PLANNING AND ZONING COMMISSION
Regular Meeting
Monday, February 29, 2016

SUBJECT: Consider recommending approval of PZ Case 16-02 an amended preliminary plat for Crosshaven Plat 7 subdividing 57.62 acres into 71 lots and two outlots. The subject property is located east of NW 100th Street and south of Little Beaver Creek.

**PZ CASE 16-02
CROSSHAVEN PLAT 7 PRELIMINARY PLAT**

**DIMENSION, PAVING
AND UTILITY PLAN**

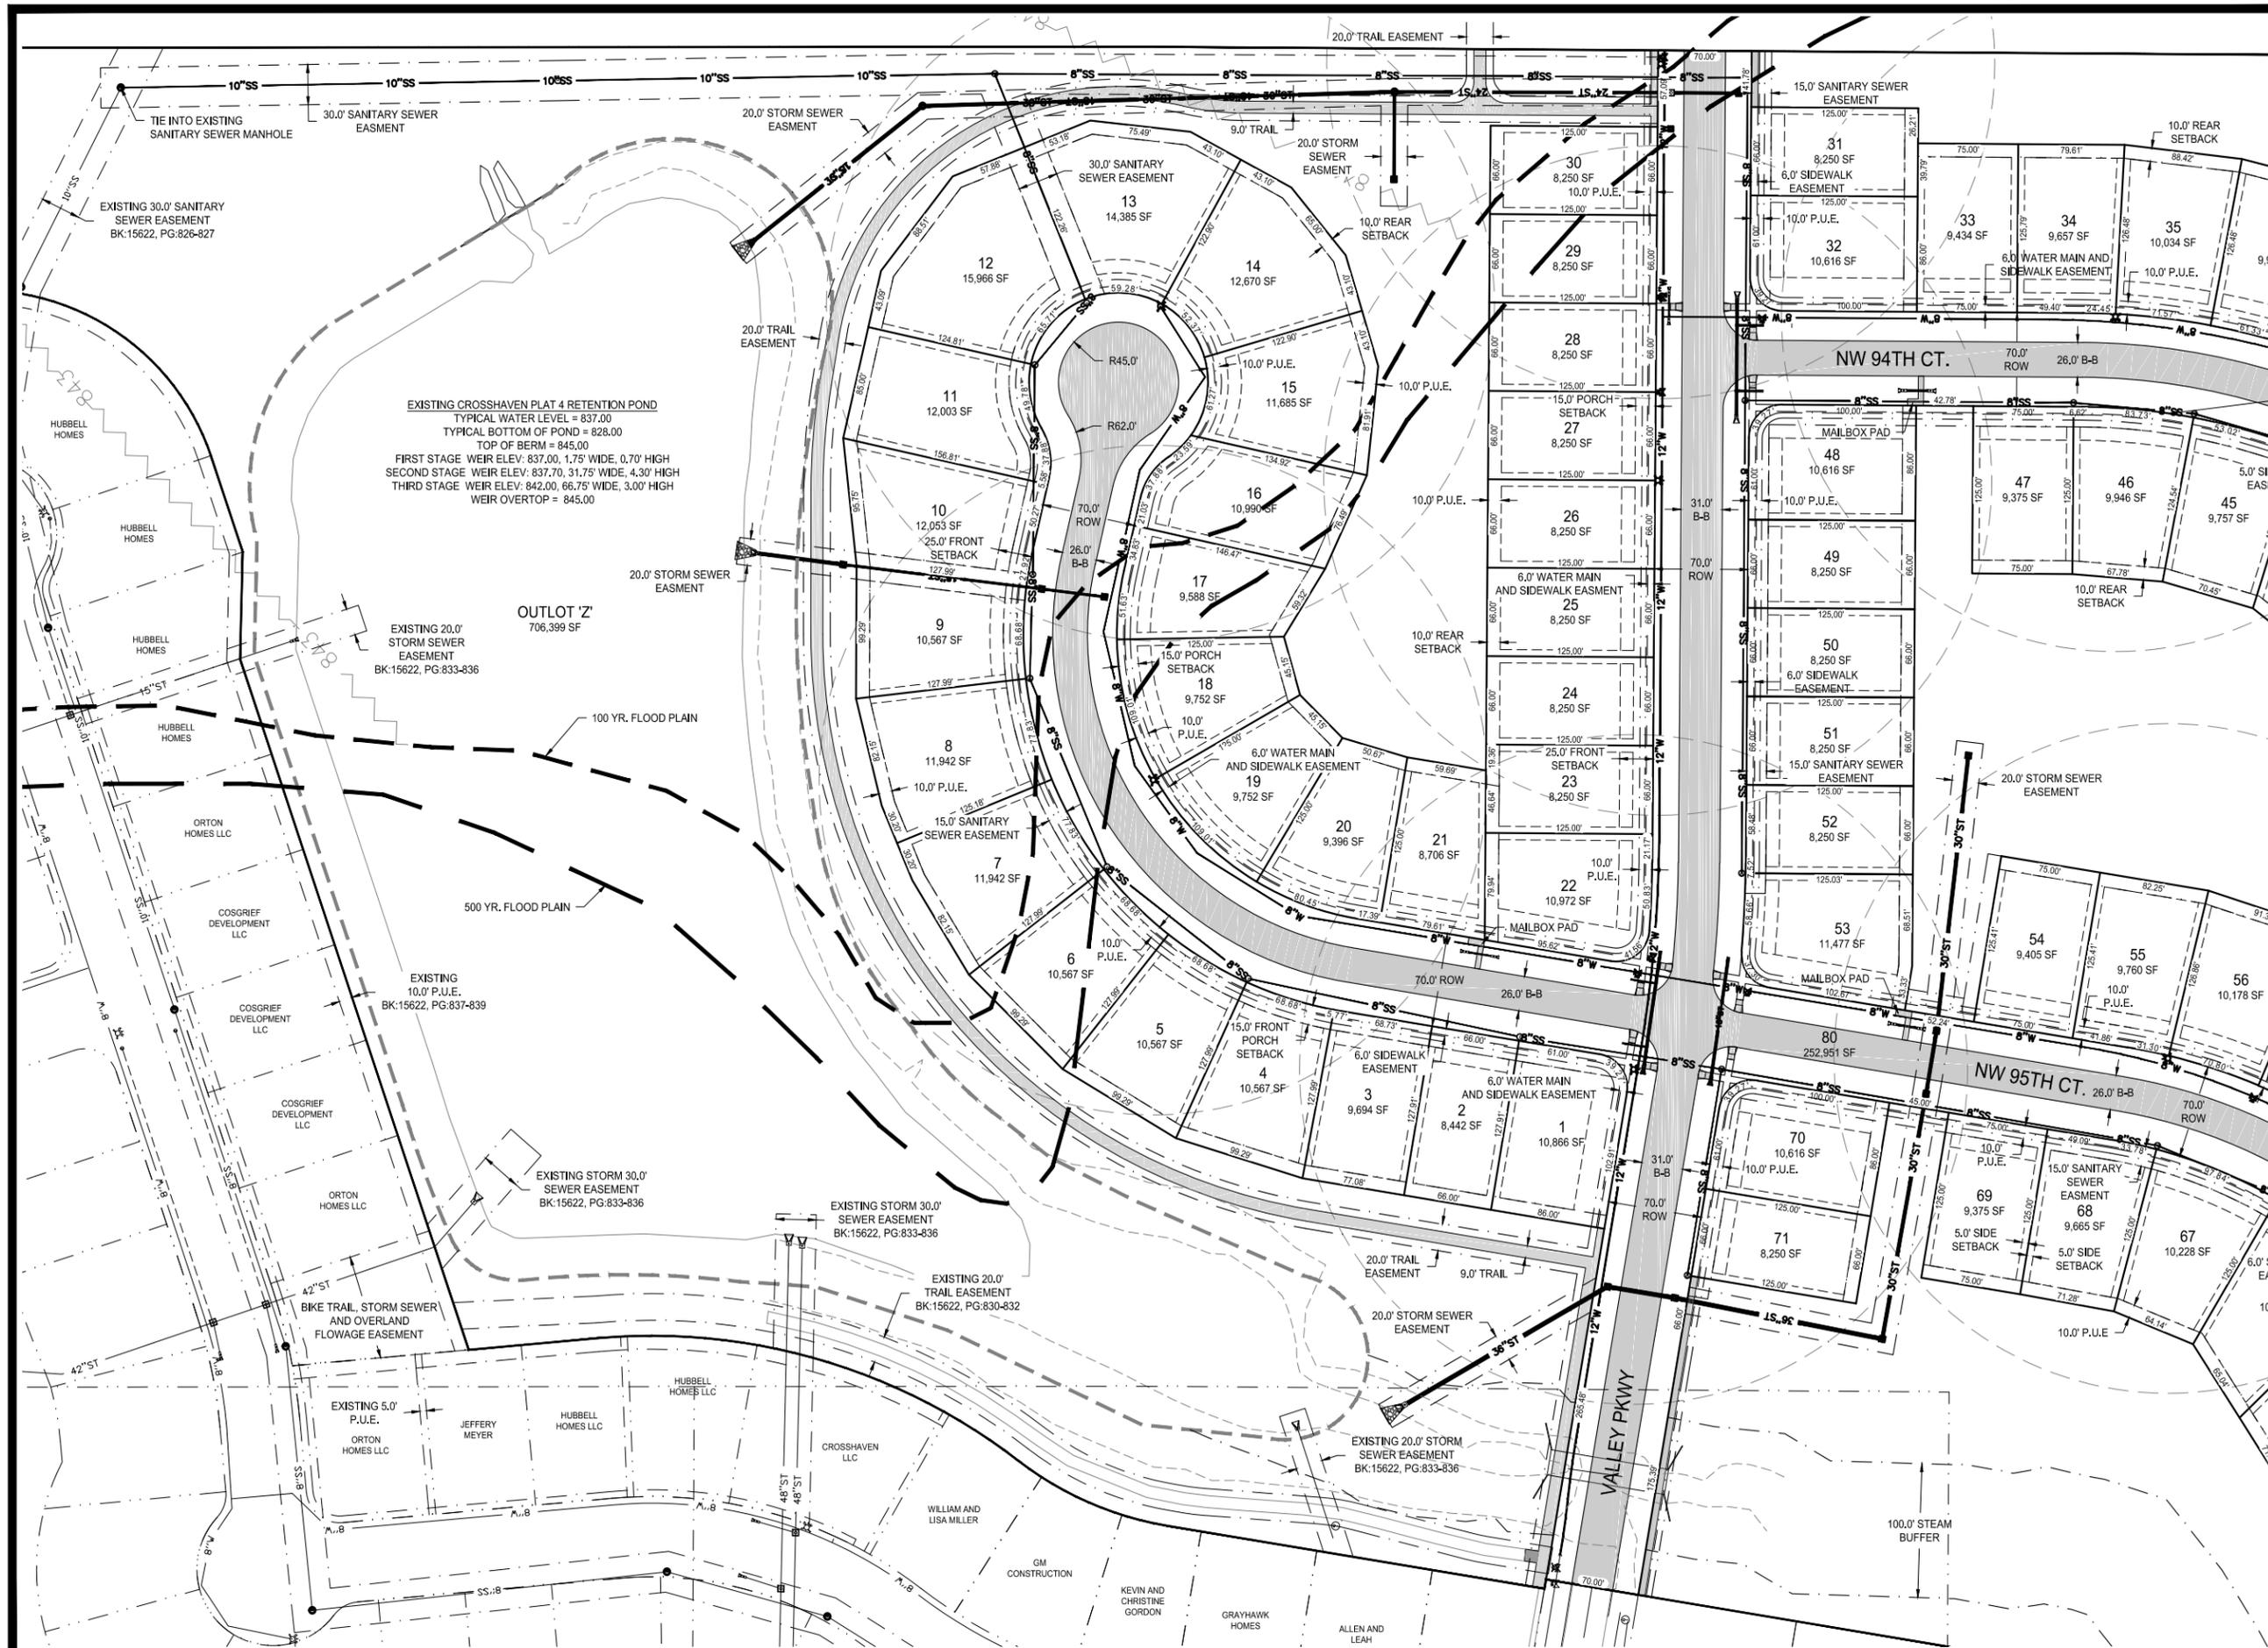
- 8) Sheet 3 & 4 – Re-align 36” storm sewer to outlet in the pond rather than the stream channel.
- 9) Sheet 3 & 4 – Please provide services for individual lots.
- 10) Sheet 3 & 4 – Specify pipe size for storm culvert under mailbox pad.
- 11) Sheet 3 & 4 – Remove pedestrian crossing to the north at the intersection of Valley Parkway and NW 94th Ct.
- 12) Sheet 4 – Add a water valve at shared lot line #36 &37.
